UNIVERSITY OF WISCONSIN  
NUCLEAR REACTOR  
LICENSE NO. R-74  
DOCKET NO. 50-156

RESPONSE TO REQUEST FOR ADDITIONAL  
INFORMATION REGARDING HEU/LEU  
CONVERSION

Subject: Docket 50-156, License R-74  
Response to Request for Additional Information  
for Amendment No. 17 to Facility License No. R-74  
University Of Wisconsin Nuclear Reactor  
TAC No. MD9592

## Responses to LEU Conversion Request for Additional Information

Figure RAI-27-1, Power and Temperature Profiles after Pulse HEU-BOL

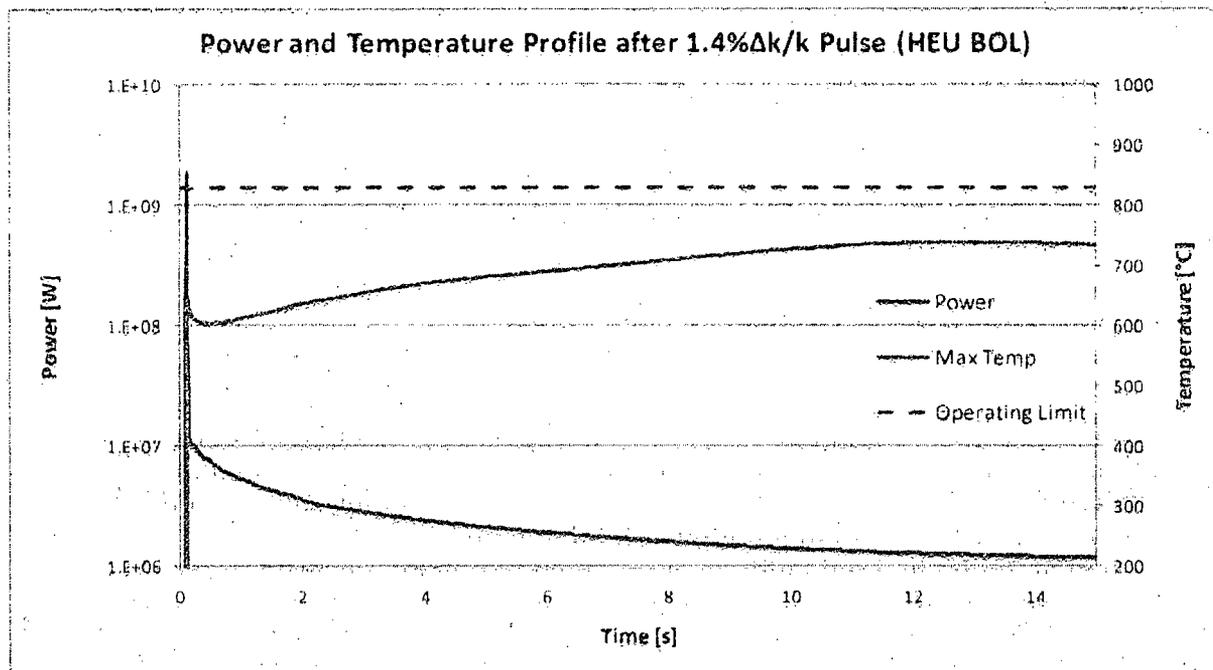
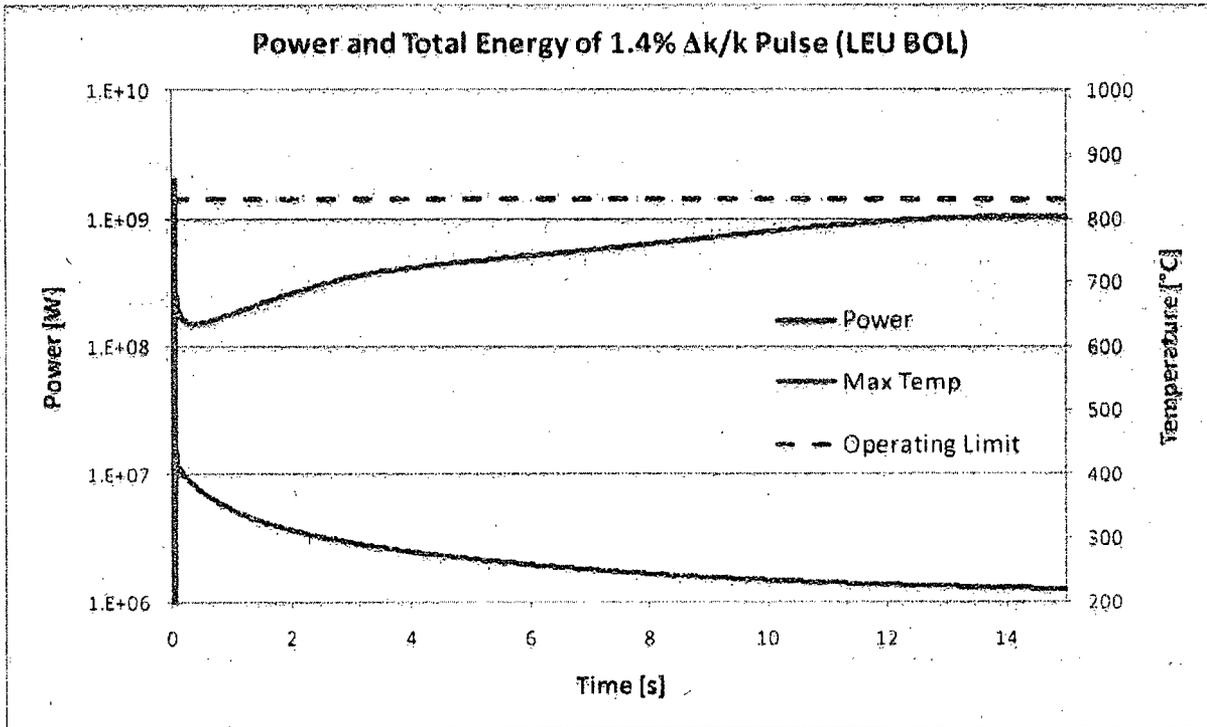
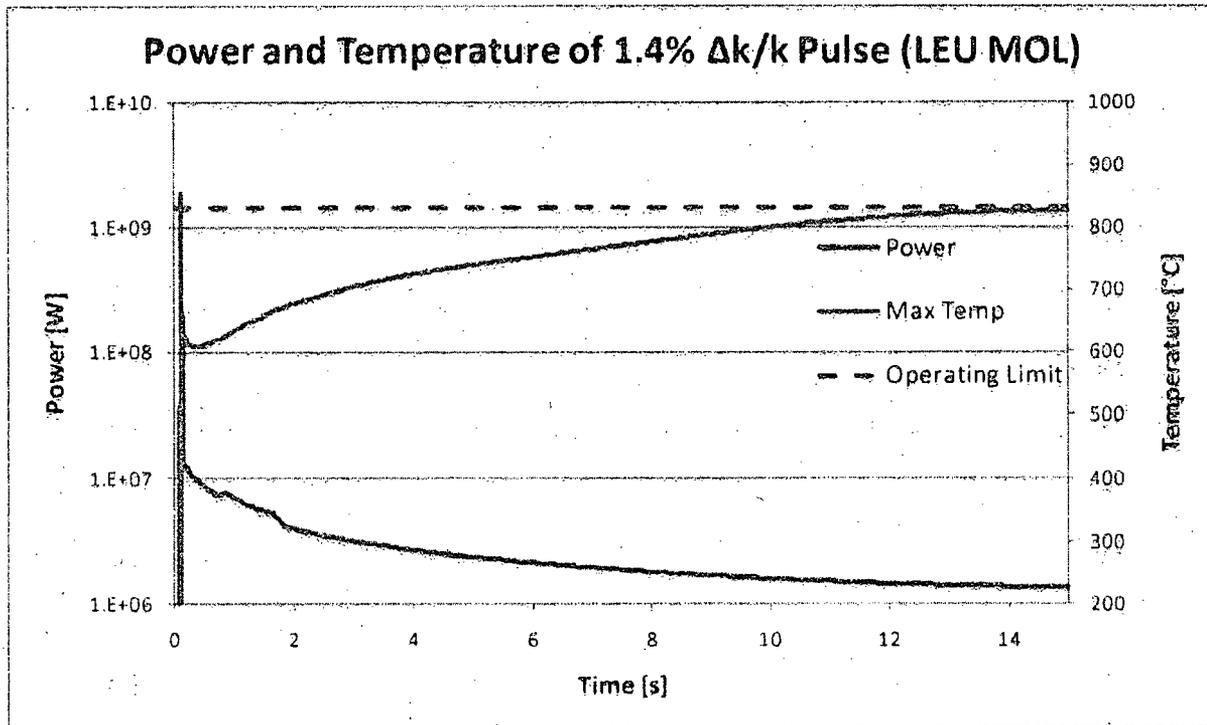
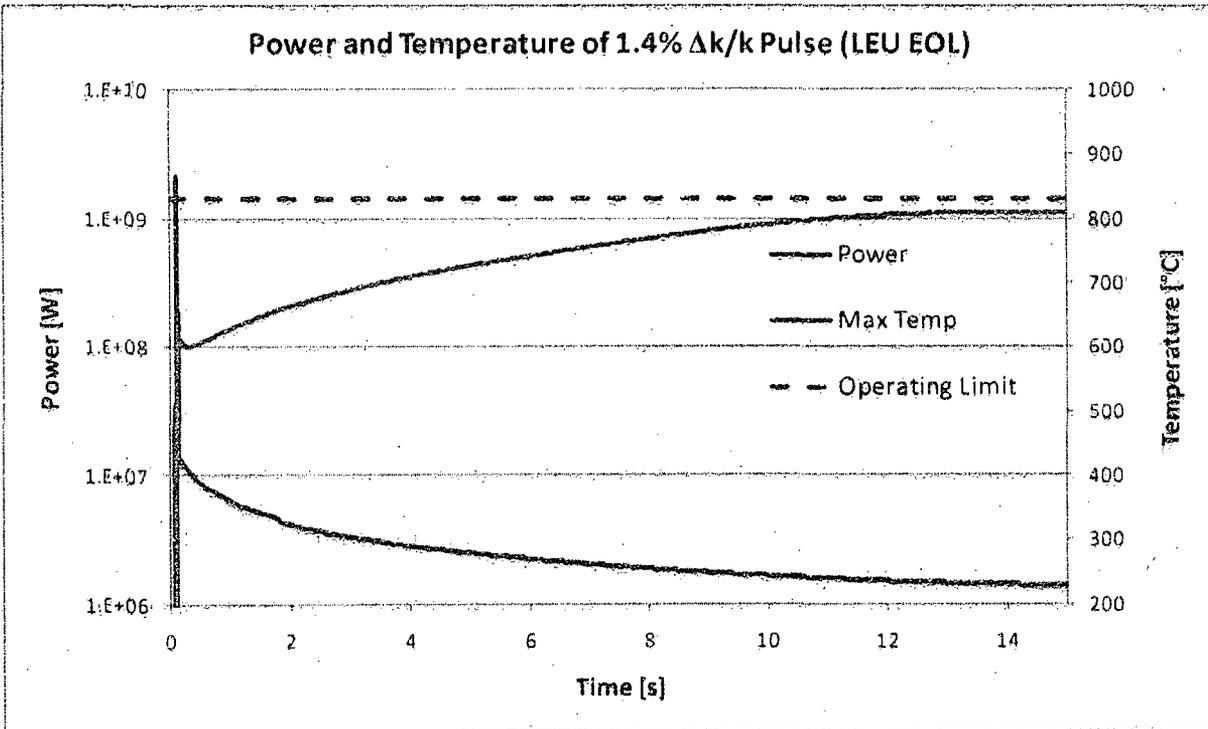
27.1.4 Figures 4.7.22, 4.7.59, 4.7.66, 4.7.73. These figures show power at about 10 MW at 0.25 second following pulse initiation. What is the power profile until the reactor scrams?

The power profile and the maximum temperature from pulse initiation until reactor scram (15 seconds after pulse initiation) for the four figures in question are given below. The revised LEU-BOL axial and radial power distributions were used.

The major change to this model was the incorporation of the additional feedback mechanisms, specifically the moderator density feedback. Due to void production during the pulse, this adds an additional negative feedback in addition to the Doppler feedback. As can be seen from these graphs at no time does the maximum temperature exceed 830°C. The maximum predicted temperatures over the 15 seconds are 738.35°C, 756.45°C, 826.15°C, and 810.25°C for HEU-BOL, LEU-BOL, LEU-MOL, and LEU-EOL respectively.

Figure RAI-28-1, Revised LEU Axial Power Distribution

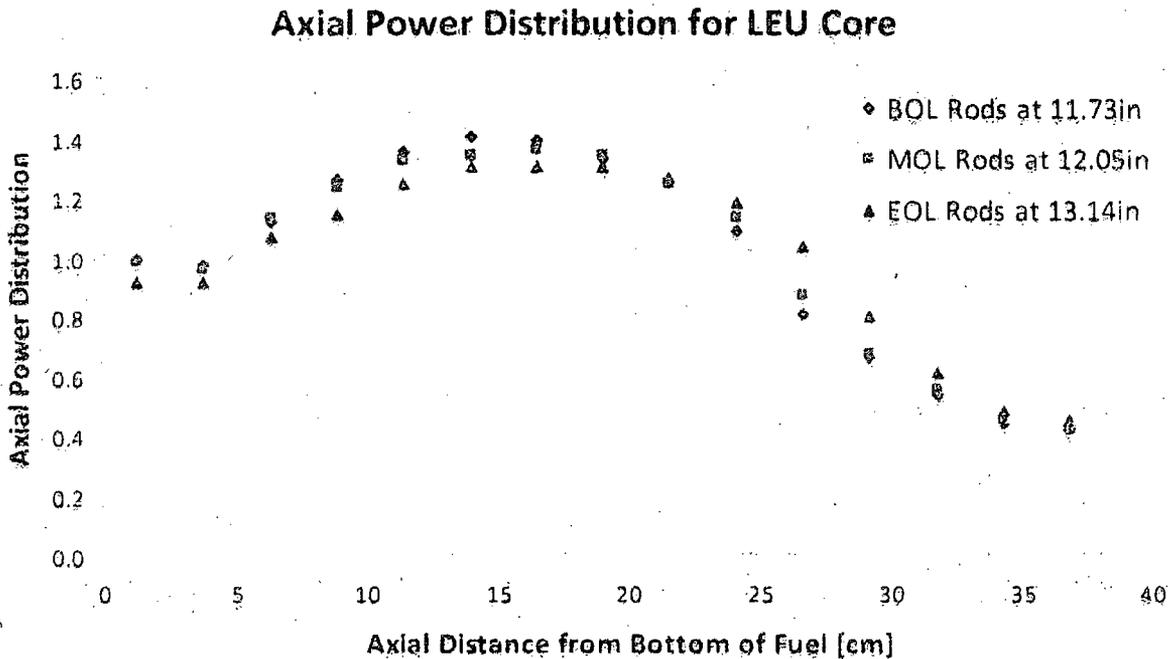
28. Section 4.7.5 in Figure 4.7.34 does the axial power distribution reflect the movement of the control blades out of the core as a function of burnup?

Yes, the axial power profiles were derived from MCNP using critical blade heights. The critical bank height moves out to compensate for core burnup. The revised LEU-BOL curve is shown in the following figure, to replace Figure 4.7.34 on page 102.

Figure RAI-55-2, Total core power used in LOCA starting at 1.02 MW (HEU BOL)

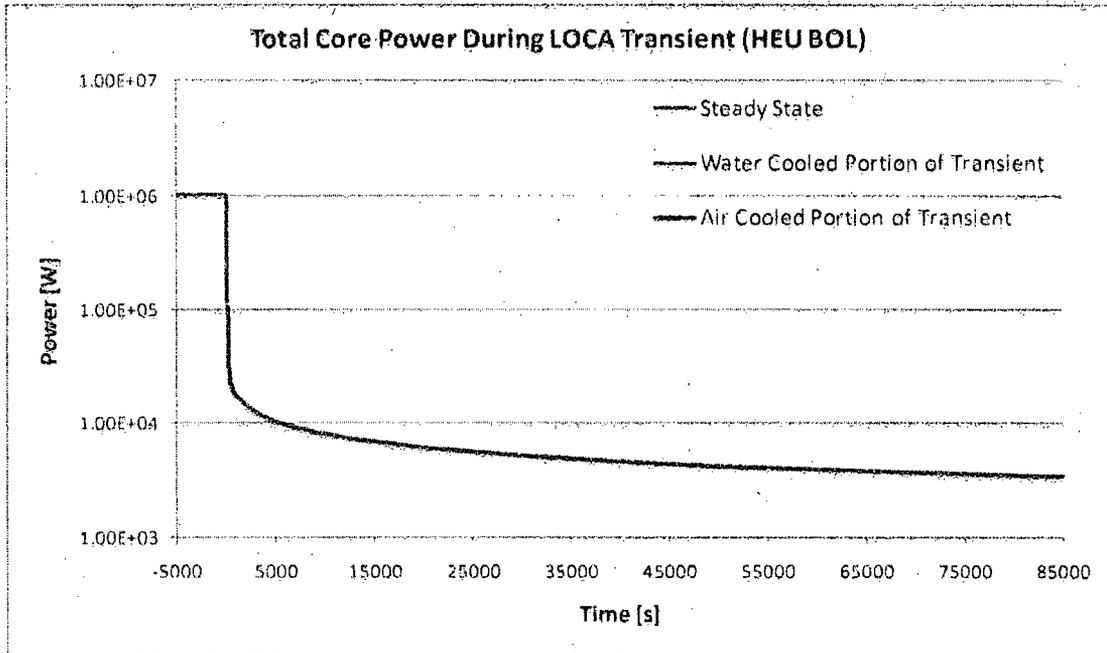
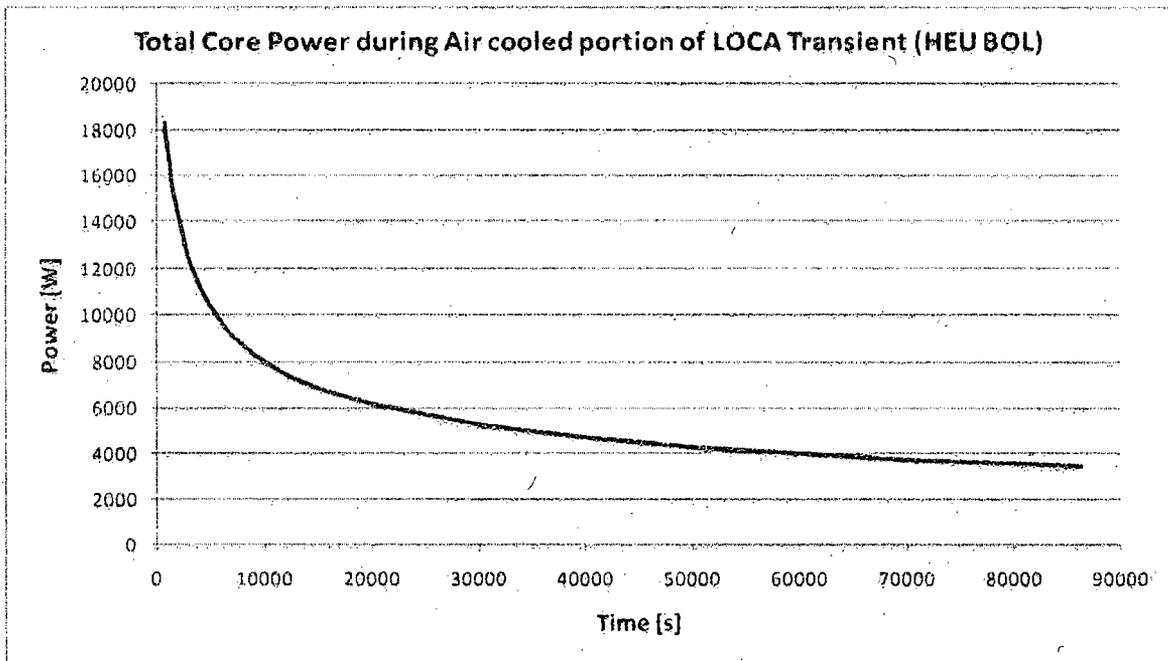
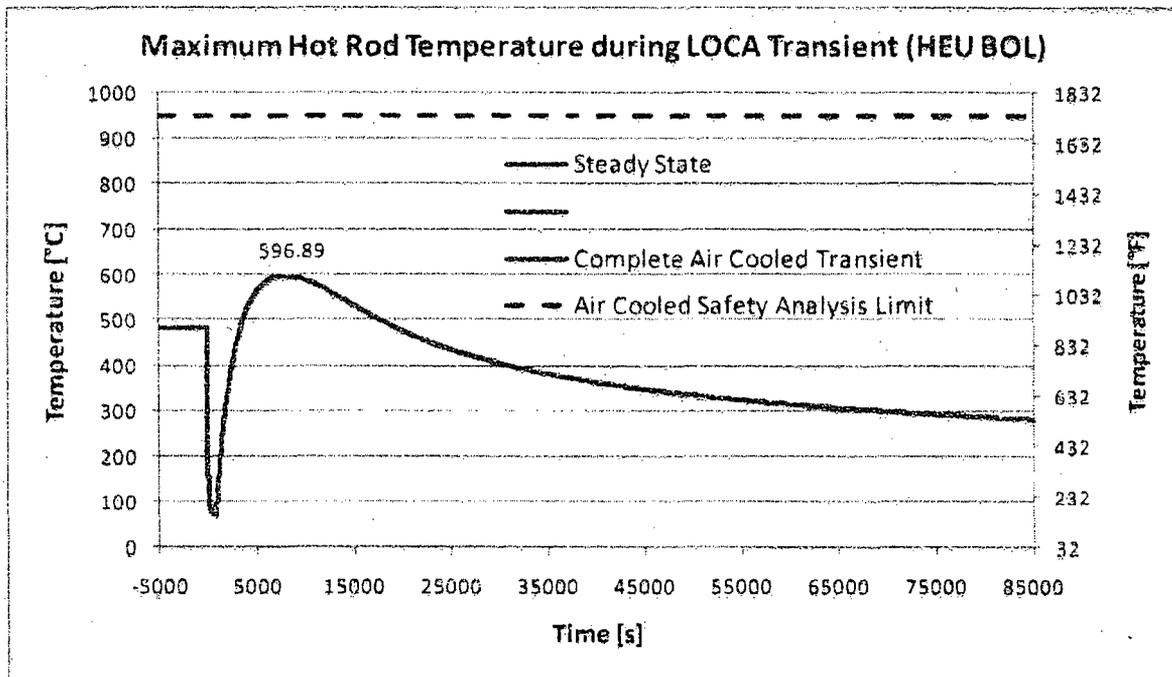
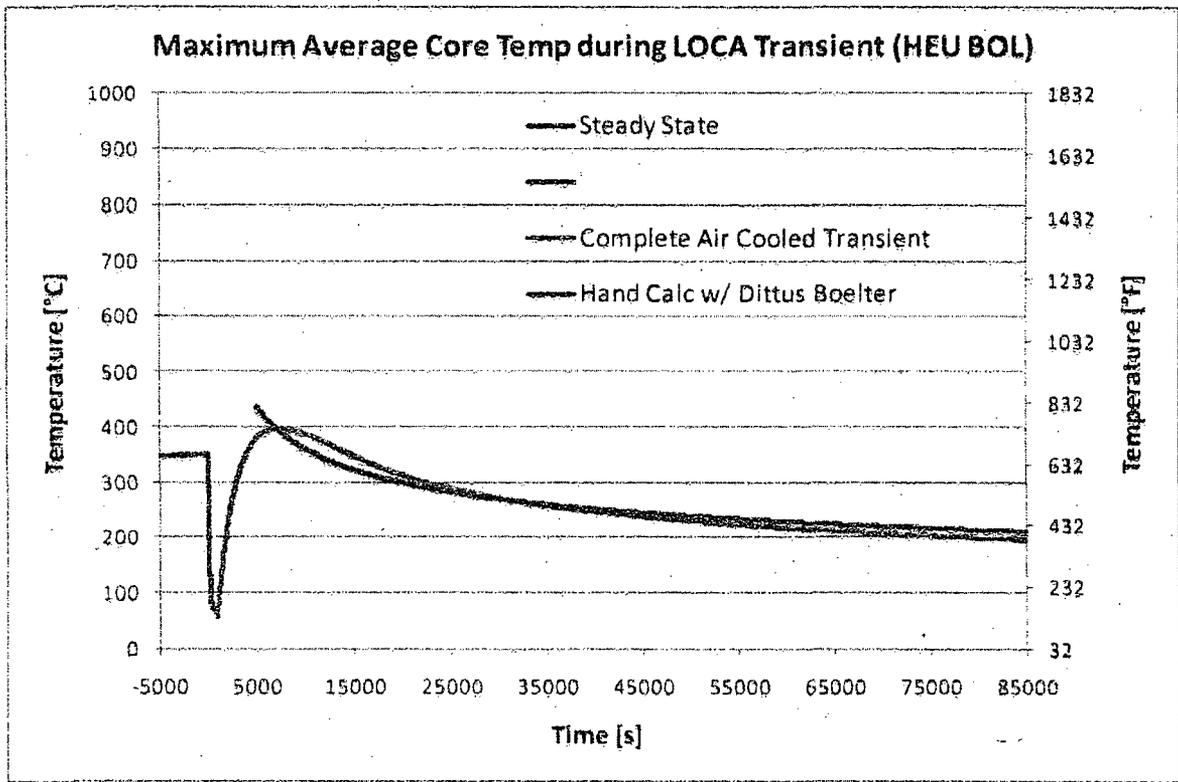
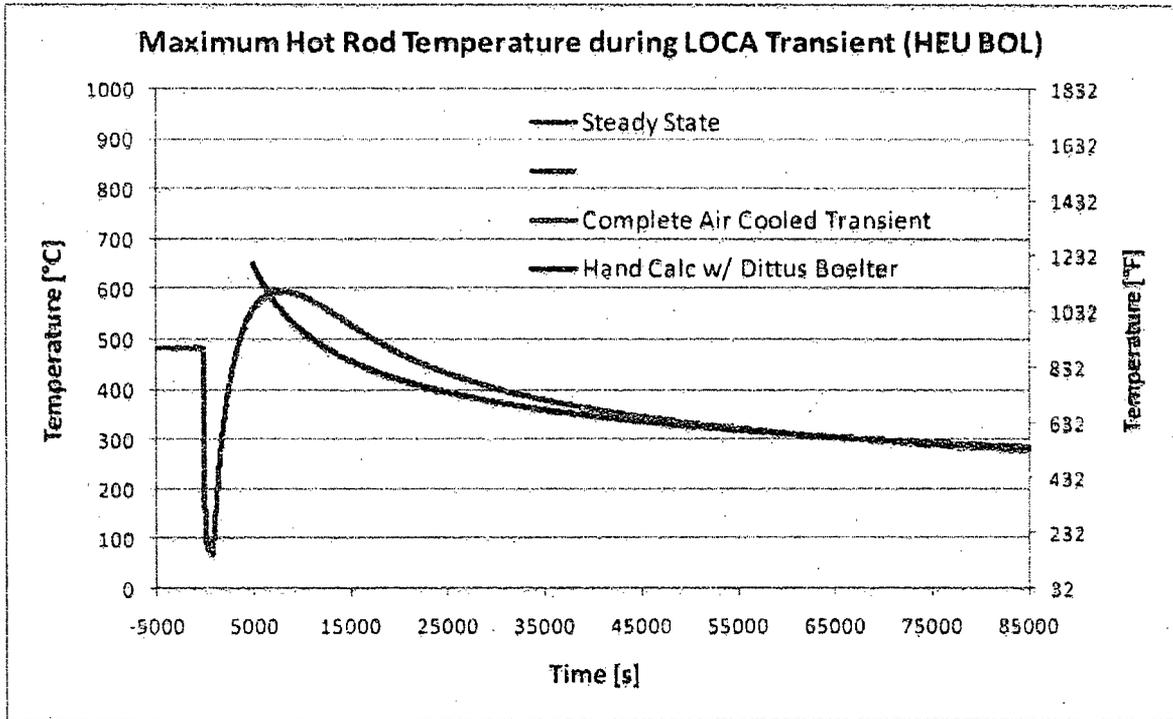
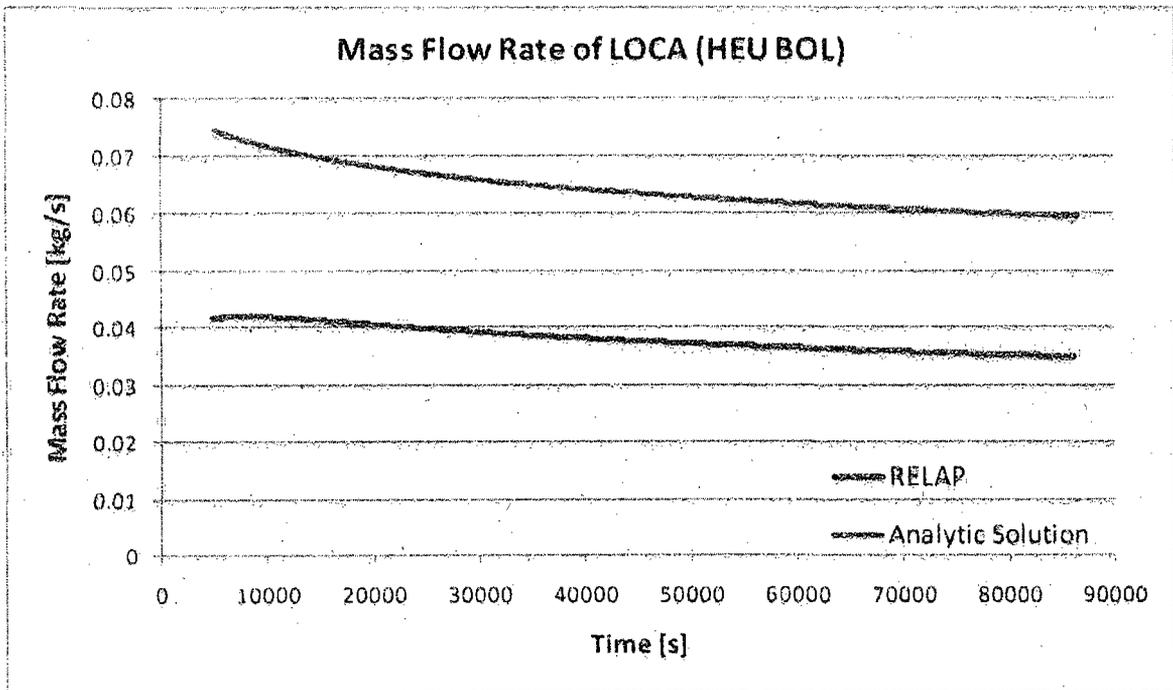
55. Section 13.3.3. Your application states analysis has been performed that demonstrates a complete LOCA is more limiting than a partial LOCA. Please discuss or provide references 33 and 34.

The summation of the fission power and the decay heat gives the final total core power curve entered into the 2-channel RELAP5/MOD3.3 model. The LOCA power curves did not incorporate the positive reactivity effects of the rods cooling down. While this would increase the fission power, it is not anticipated to effect the total power curves computed for the air cooled transient. The total power curve for HEU BOL is shown. The entire total core power transient is shown in Figure RAI-55-2, and the air cooled portion of the transient is shown in Figure RAI-55-3. Further analysis will follow for LEU BOL, MOL, and EOL cases. The core exposure for LEU was 50 MWd for BOL, 800 MWd for MOL, and 1800 MWd for EOL. The input conditions for all stages of core life are shown in Table RAI-55-1.

The maximum temperature for HEU BOL during the air cooled portion of the transient was calculated to be 596.89°C (1106.40°F). This temperature occurs 7,750 seconds from the initiation of the accident. While clearly a LOCA is a significant accident, no damage to the fuel is predicted since the fuel temperature does not exceed the SAL.

Figure RAI-55-5 shows that the analytic solution and the RELAP5 solution for the core averaged channel give very similar results from about 25,000 seconds onwards. The analytic and RELAP5 solutions diverge during the peak portion of the transient since this is still in the transient region. The maximum difference between these two lines is approximately 45°C around 12,500 seconds. In order to compare with the hot rod temperature, the total core power was artificially increased by the hot rod power peaking factor, 1.6. This produced a maximum temperature profile as shown in Figure RAI-55-6.
